# Illustrated Parts List - IPL Update

**H435e II**

1. Oil hose

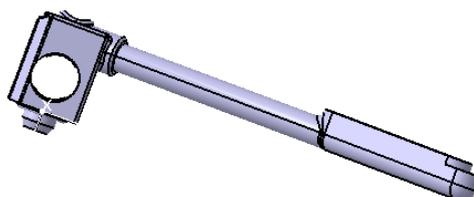
1. Updated Oil Hose 544 08 42-02 added. Sealing knob removed to simplify assembly.

Page Title	Ref. no	New part no.	Name	Excl. part no.	Remark
Clutch & Oil pump	8	544 08 42-02	Oil hose	544 08 42-01

This change is fully exchangeable.
